Annual Monitoring Report

Monitoring Year 6 of 7

Pee Dee Stream Restoration Project
NCDMS Contract No.: 004644
NCDMS Project No.: 95350
USACE Action ID: SAW-2012-01077
DWR #: 13-1140

RE: Pee Dee Stream Restoration Site: MY6 Monitoring Report (NCDMS ID 95350)

2019 Adaptive Management Map

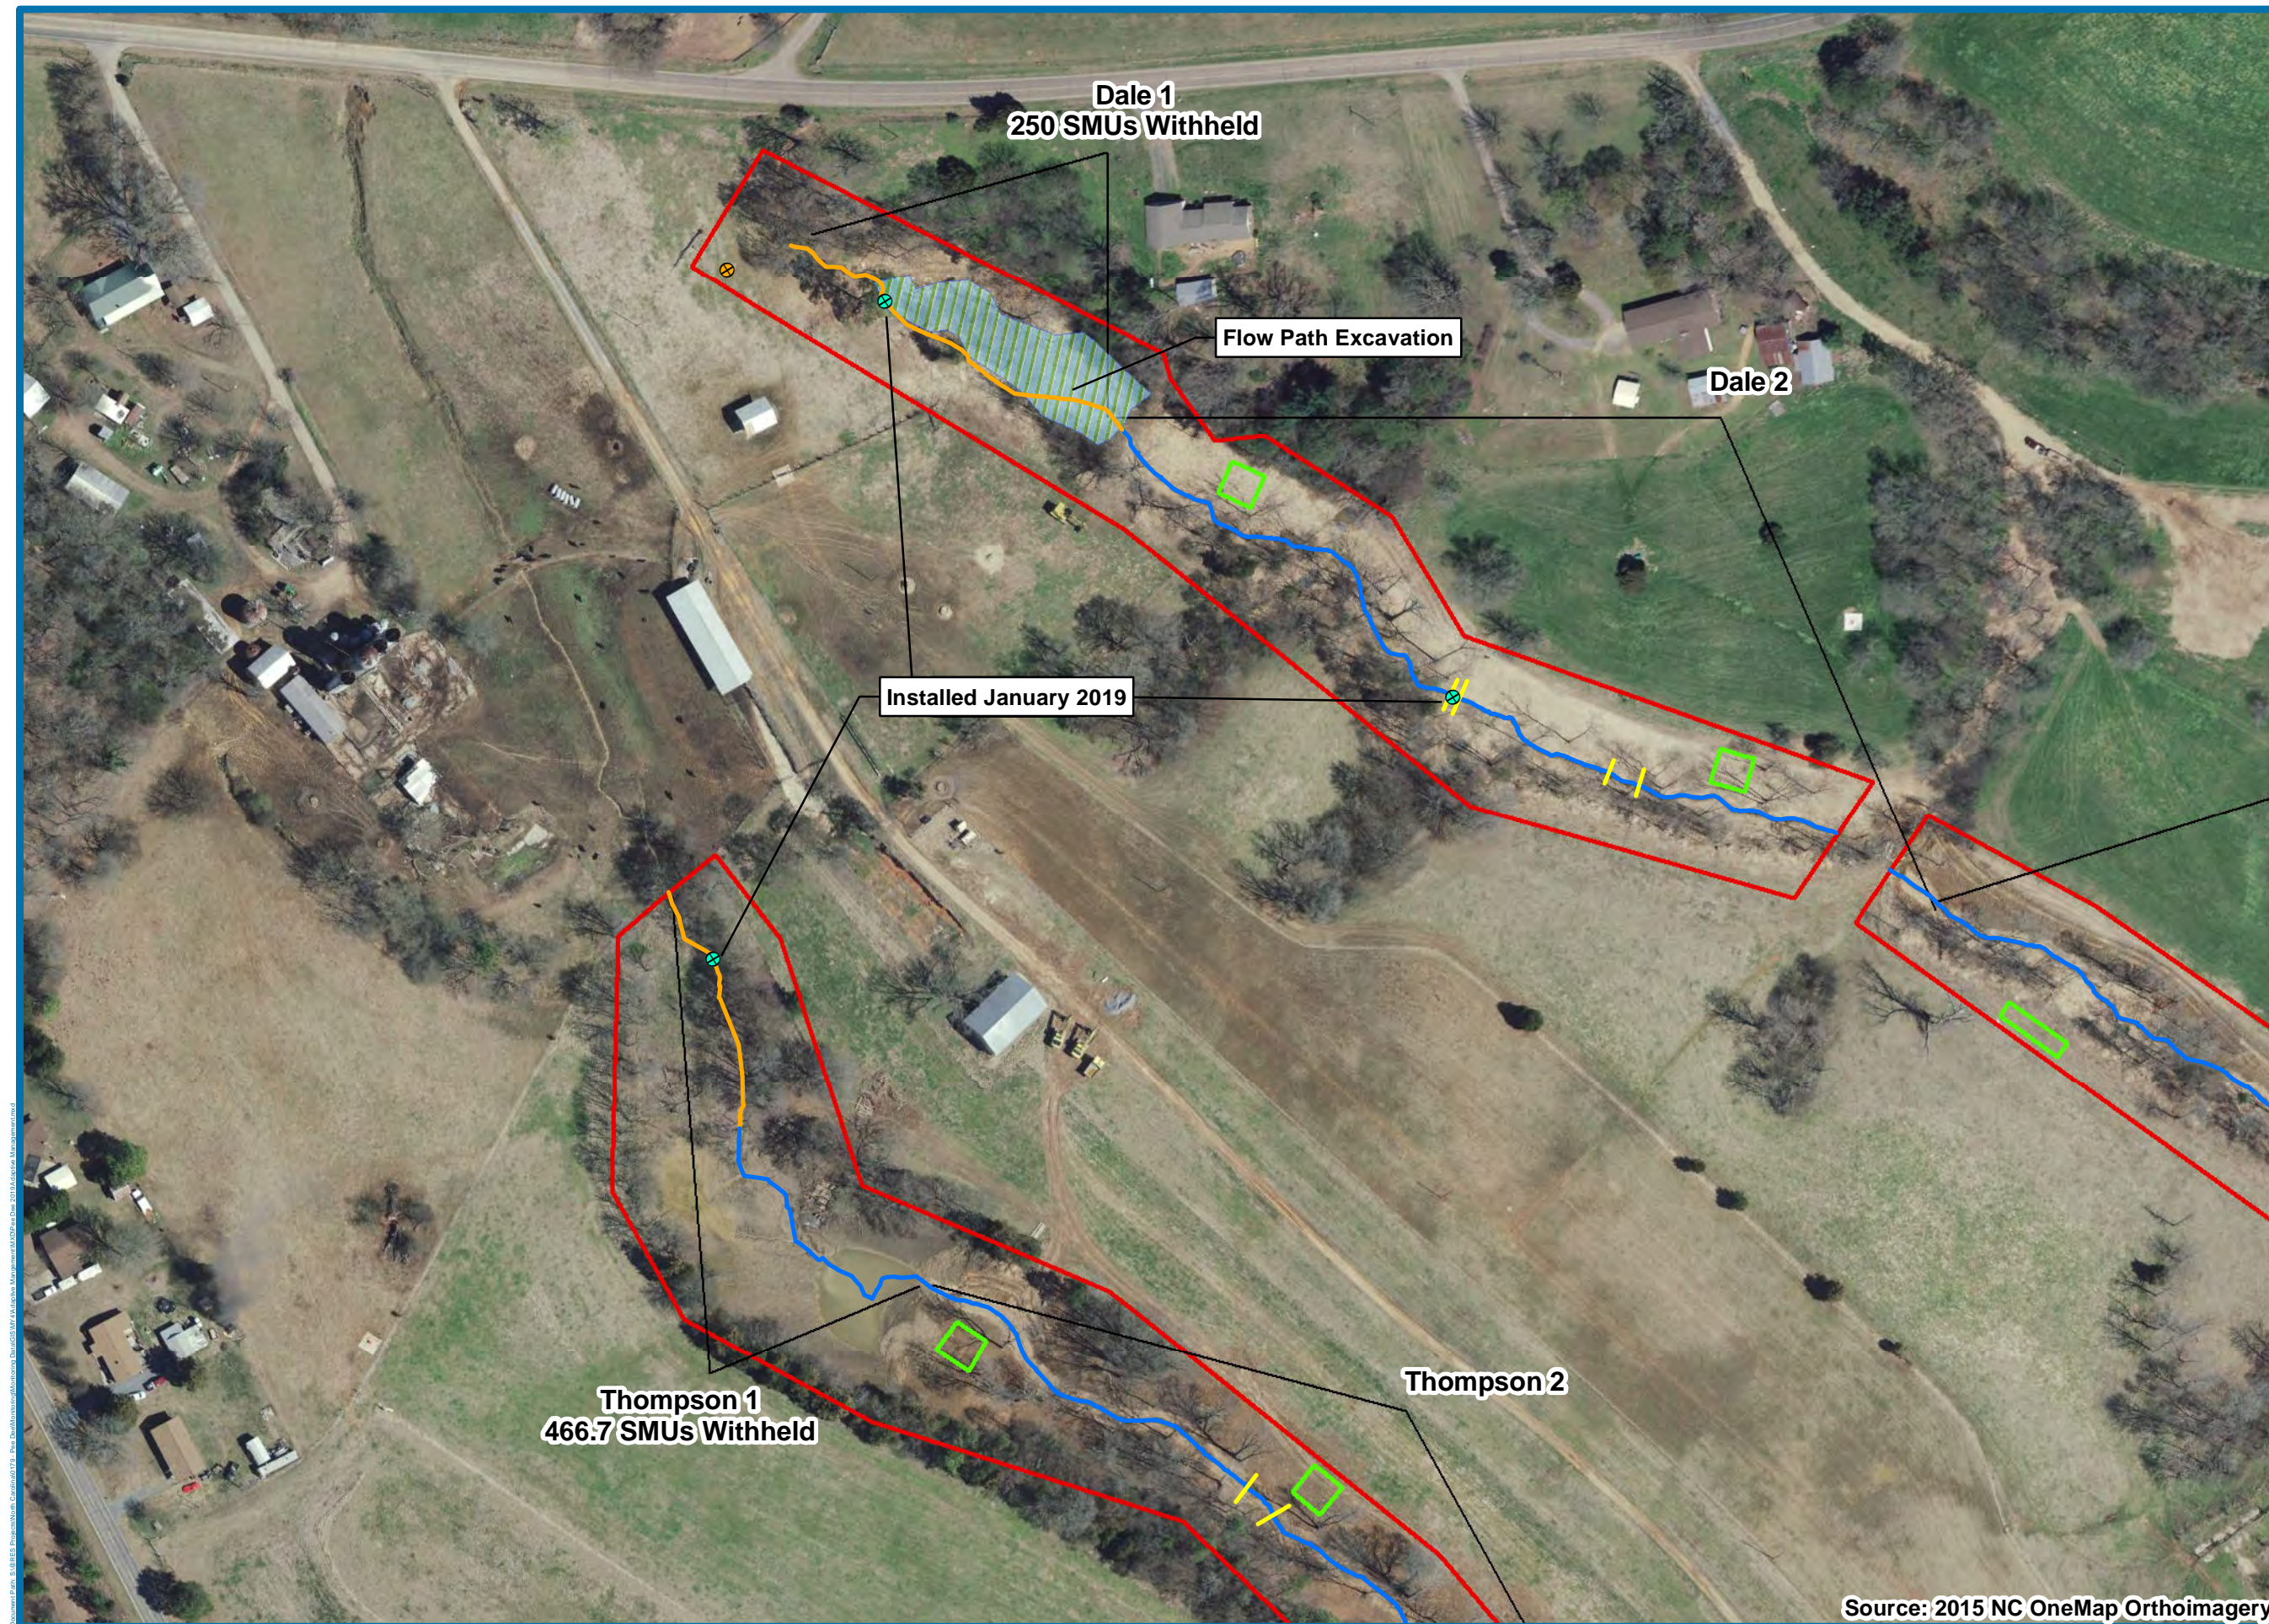
In general, I agree with all responses and approaches to adaptive management that RES proposes to correct site deficiencies and resume credit release at the Pee Dee site. My only comment is that RES should clearly state the stream mitigation units that the proposed action will release or those that are no longer being sought such as the Thompson 1 old pond bottom that is not being reworked for credit (due to budgetary constraints).

I am ok with the proposed Modification Plan. However, I would like some clarification as to how they are measuring stream flow given the placement of the flow gauges. I am assuming they are adjusting the elevation to the riffle above or below, since they are all located in pools.

I question the flow, and functional uplift, of including the reach above the cracked pond bottom. I generally agree with the adaptive management plan, especially the need for flow gauges on the reach above the pond and the privet treatment.
